# BUC-EE'S #87 EL PASO COUNTY OFFSITE SEWER
# 100% DESIGN DOCUMENTS

PPR26-28

BUC-EE'S #87 EL PASO COUNTY OFFSITE SEWER
COVER SHEET

VICINITY MAP
1" = 1'

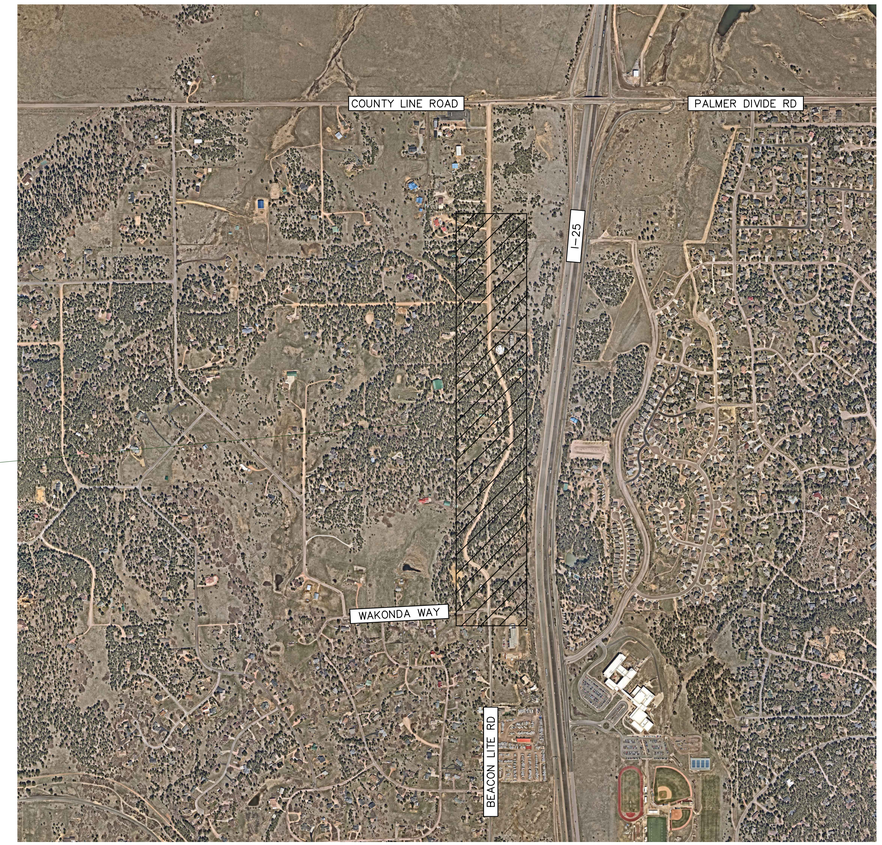
Please add the force main and sewer line alignments (unique symbol to be used)

# FORCE MAIN STA 1+00 – END
# PLAN & PROFILE

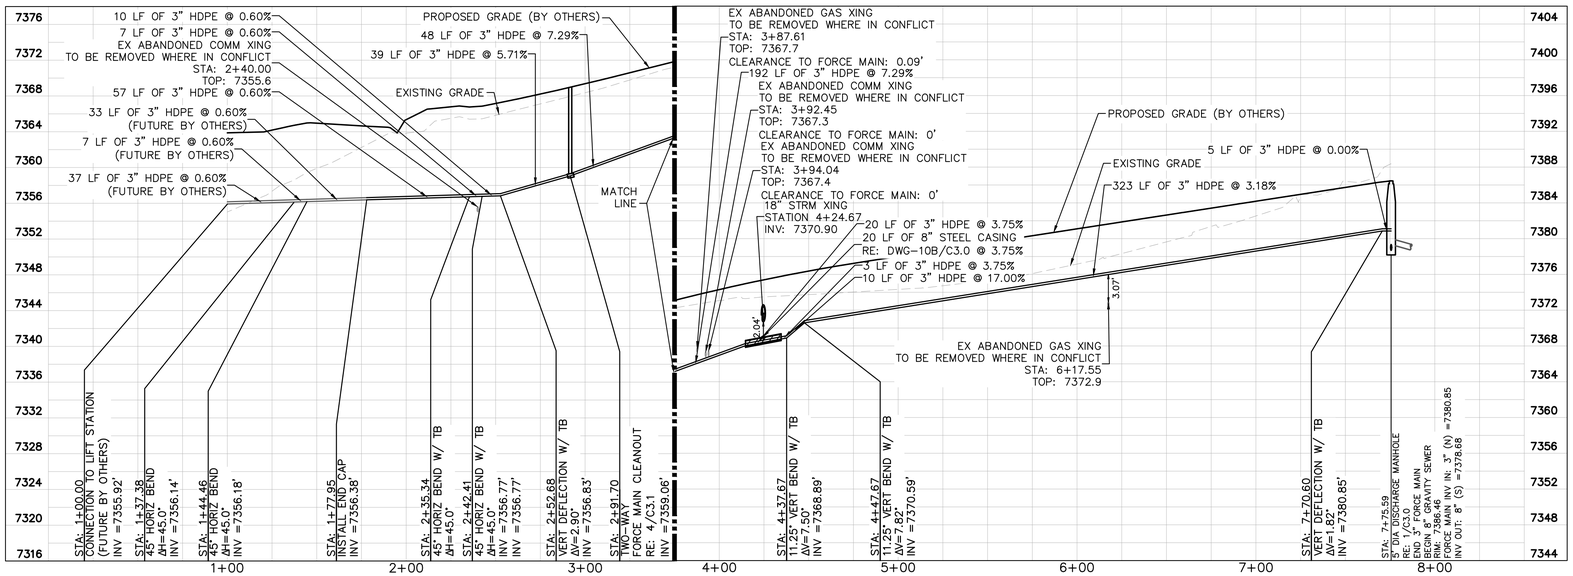
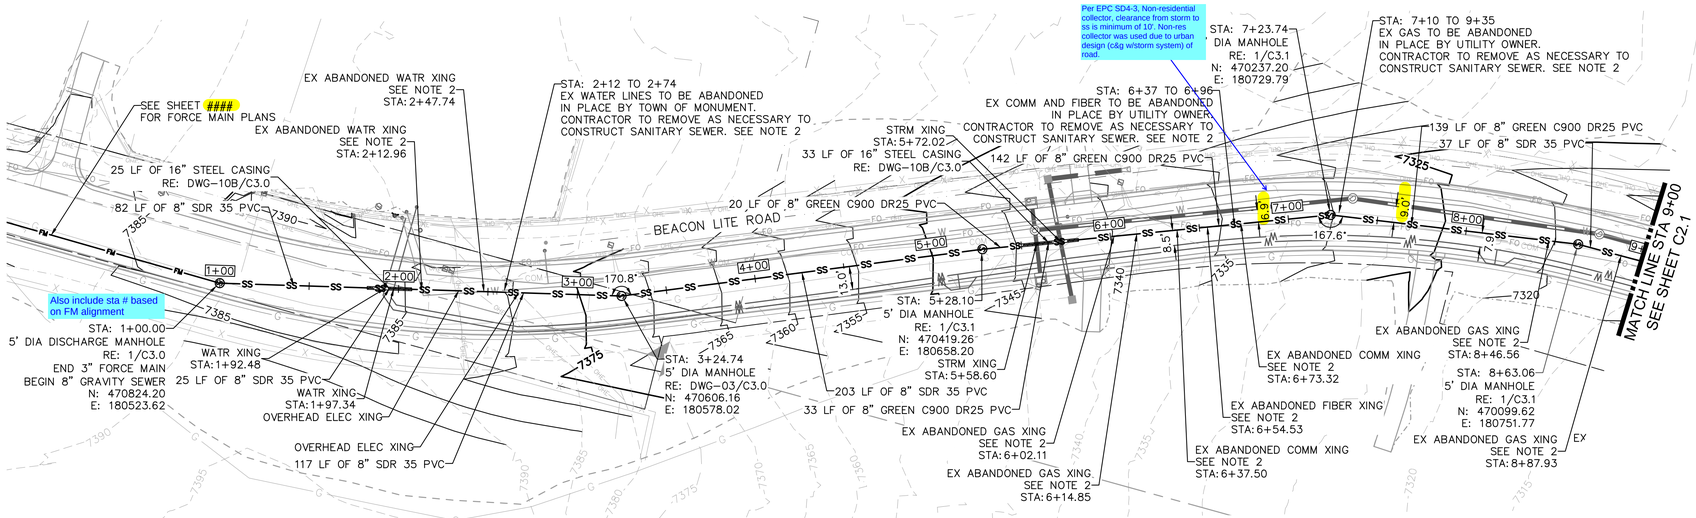
Show EPC/TOM jurisdictional boundary

Ensure keymap shows same information as other sheets

Label Key map and include scale and north arrow (all sheets)

Label adjacent property owners

Show and label ROW

Ensure all easements are shown and labeled

Also include sta # based on SS alignment

# SANITARY SEWER STA 9+00 – 16+00
## PLAN & PROFILE

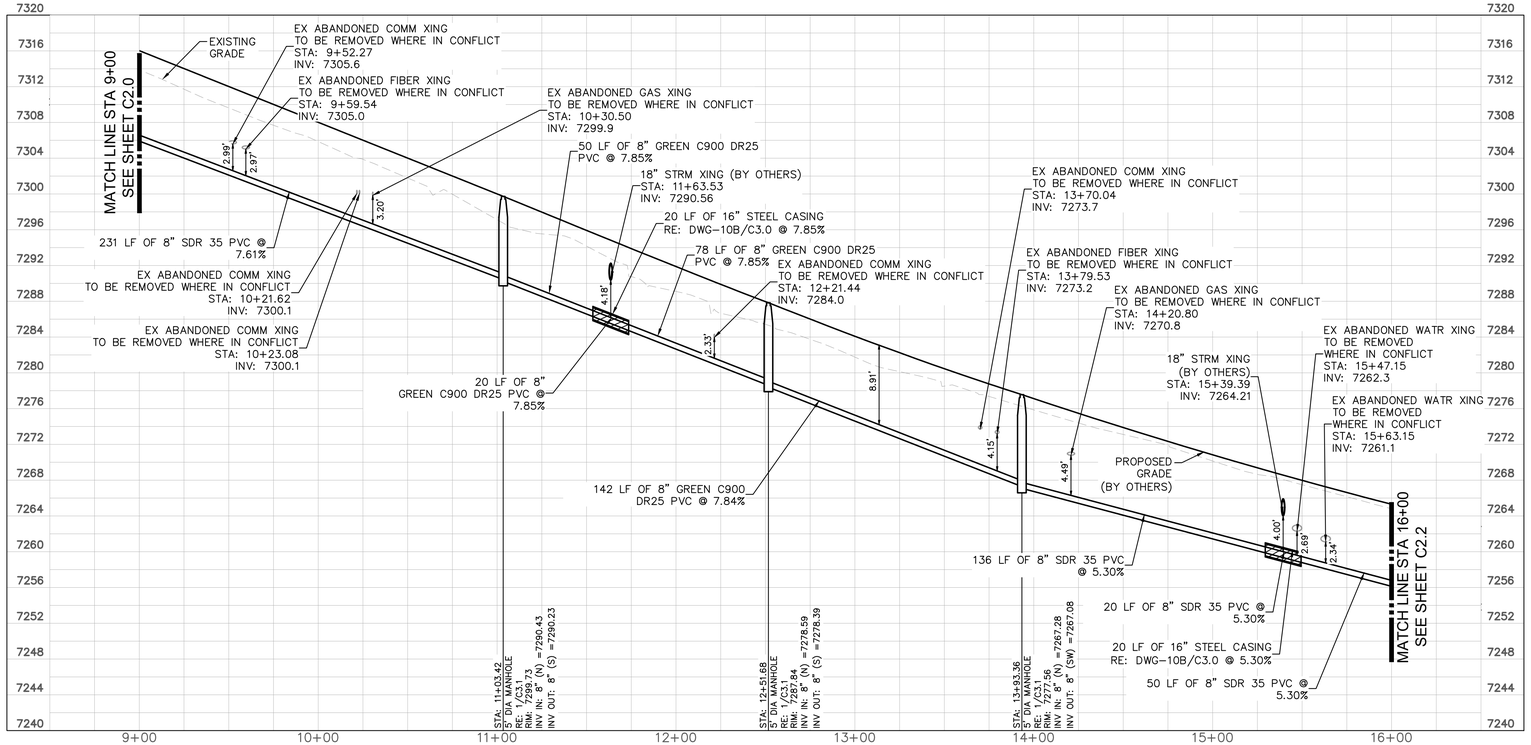
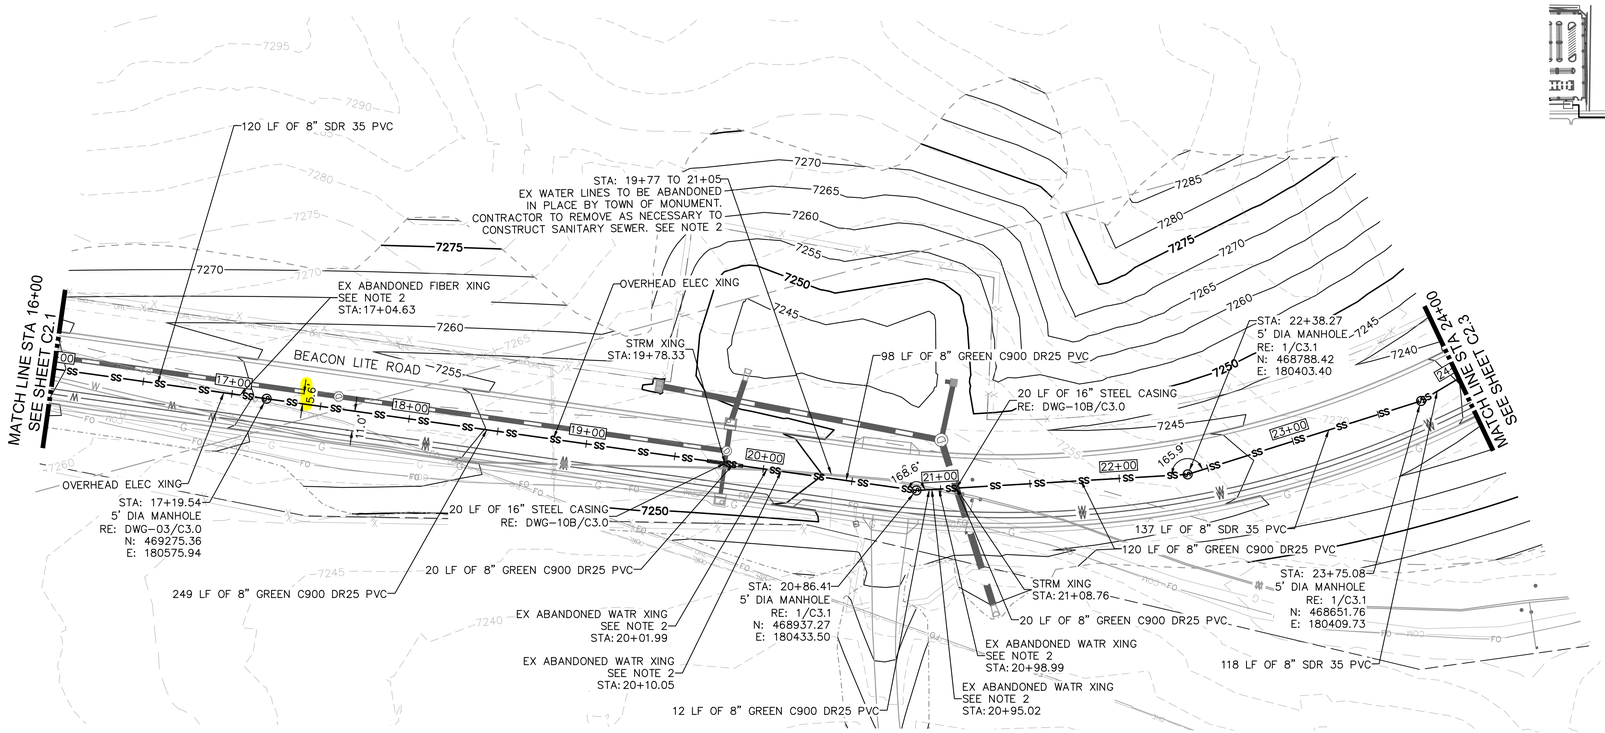
See comments from previous sheets

# SANITARY SEWER STA 16+00 – 24+00
## PLAN & PROFILE

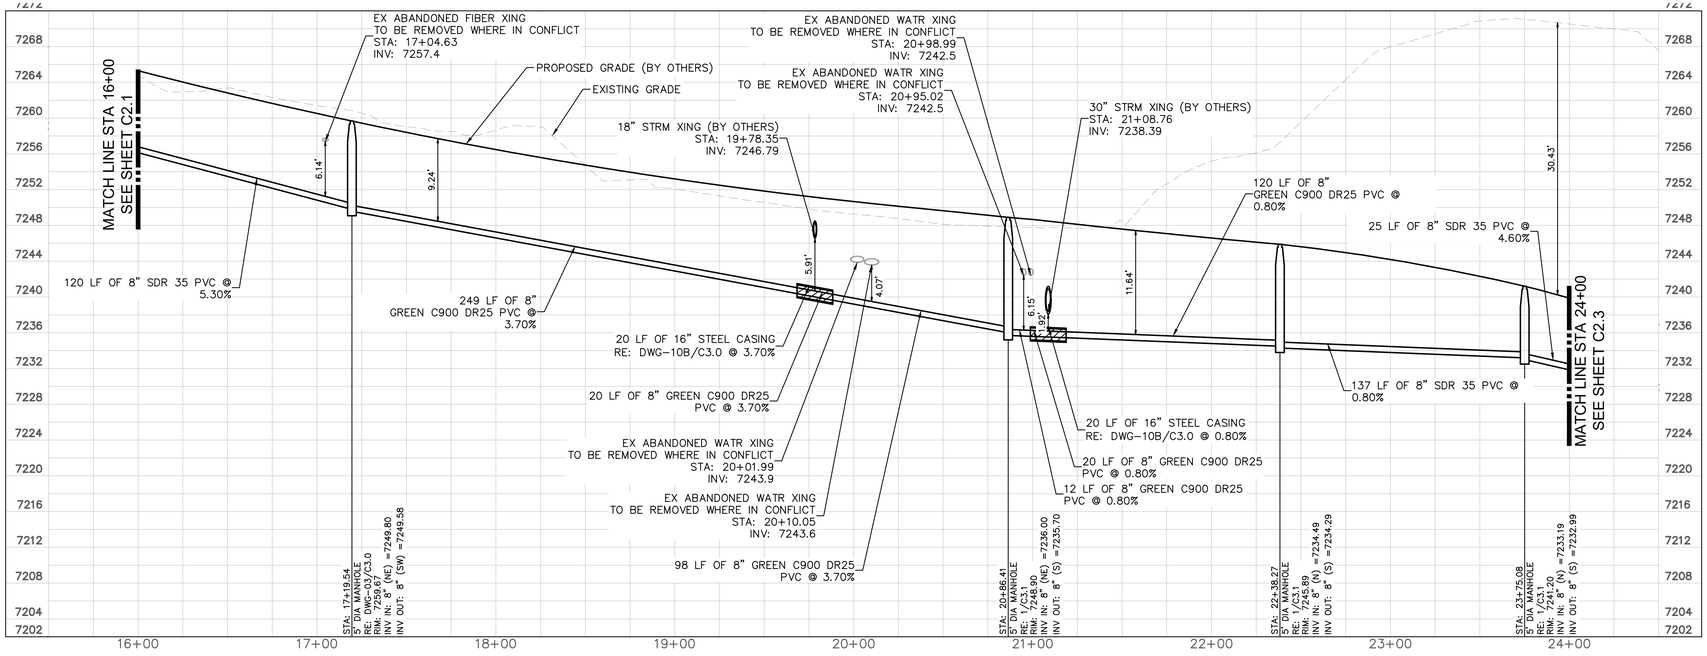
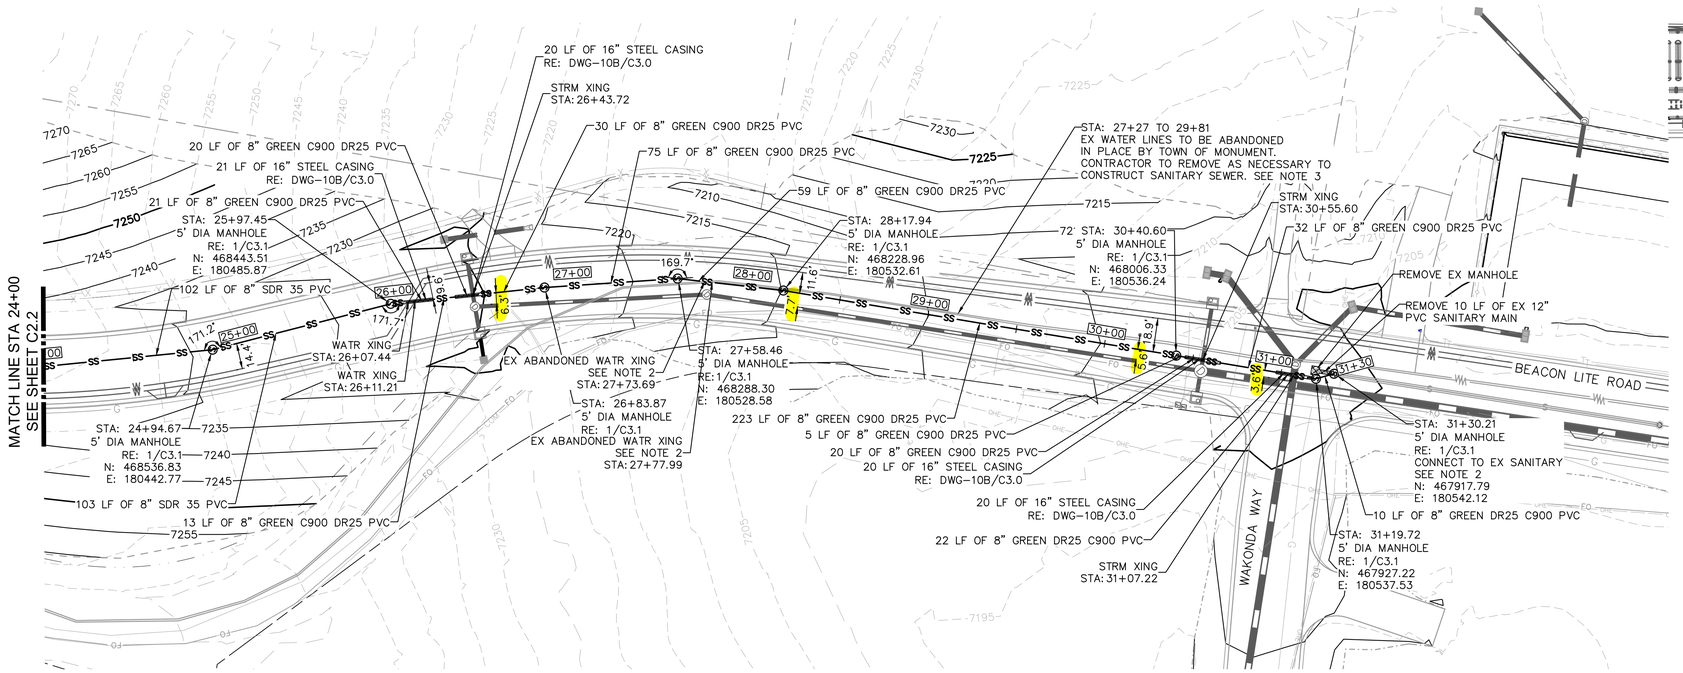
See comments from previous sheets

# SANITARY SEWER STA 24+00 – END
## PLAN & PROFILE

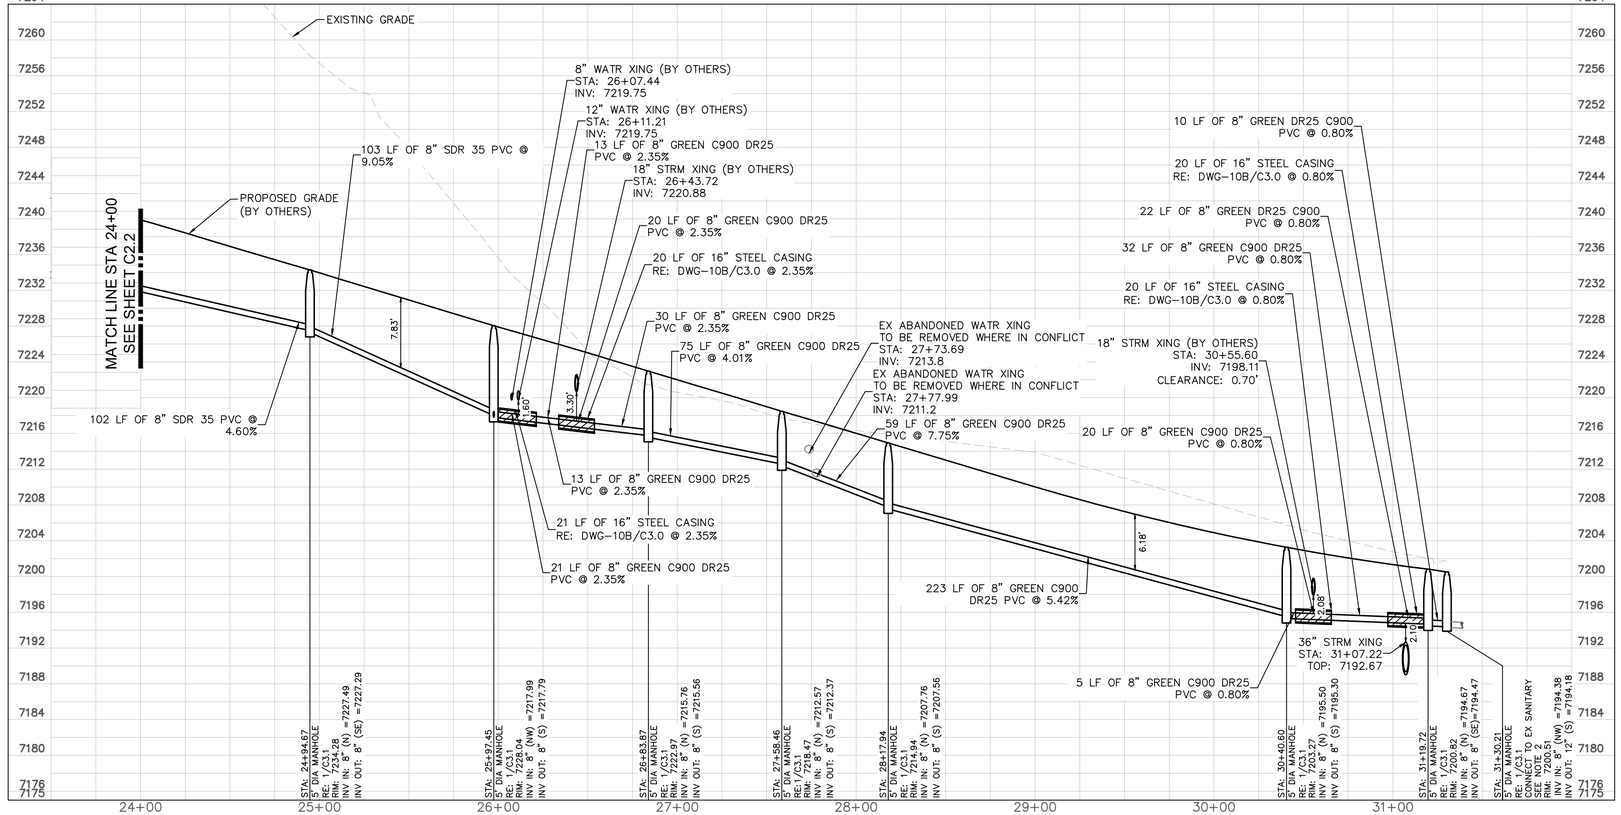
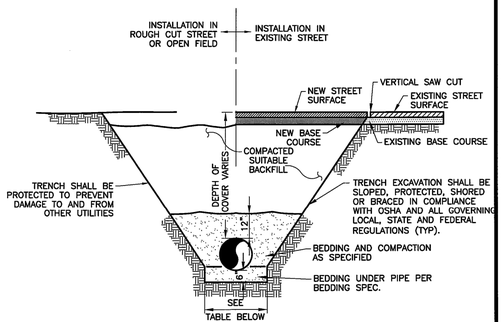
See comments from previous sheets
